Grant PUD's Response to the USBR's April 27, 2020 Comments

As part of its customer engagement process for developing an updated transmission (wheeling) cost of service study (COSS or Study), Public Utility District No. 2 of Grant County (Grant) requested comments and feedback regarding its draft transmission (wheeling) COSS models.

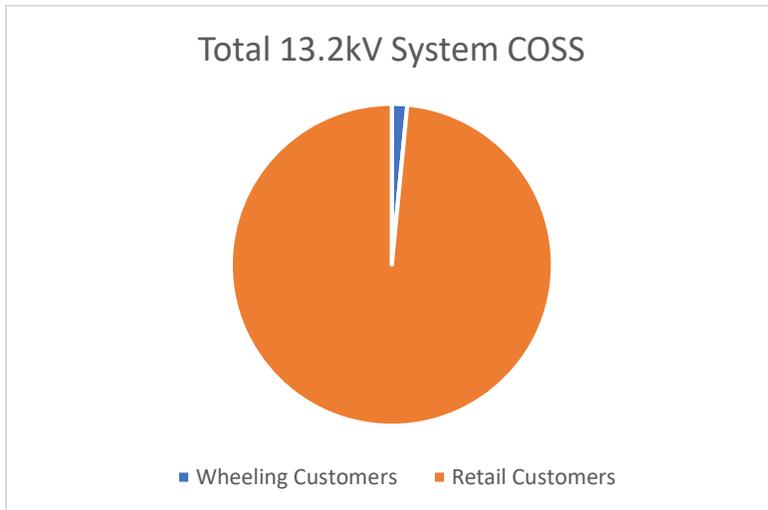
Plant Distribution Factor. USBR and the Districts believe that the 68.02% allocation factor is an over-recovery. For reference, 45% of the Distribution system is used to transmit 13.2kV and USBR loads only make up about 3% of the wheeling customer base. What rationale is being applied to justify an allocation factor at this percentage to be recovered through USBR wheeling? This allocation factor appears high.

USBR argues that it uses 45% of the Distribution system to transmit 13.2kV and that USBR’s load only make up about 3% of the wheeling customer base and that staff’s 68.02% is too high. USBR did not provide further support for its argument. Staff was unable to determine the origin of USBR’s 45% and 3% amounts.

Staff estimates that the 13.2kV transmission wheeling customers using this service will contribute approximately \$615,796 towards the allocated distribution cost of service of \$39,318,801, or approximately 1.57%, see Chart 1.

The remaining distribution cost of service of \$57,192,331 will be pay by Grant’s retail customers, see Table 7:
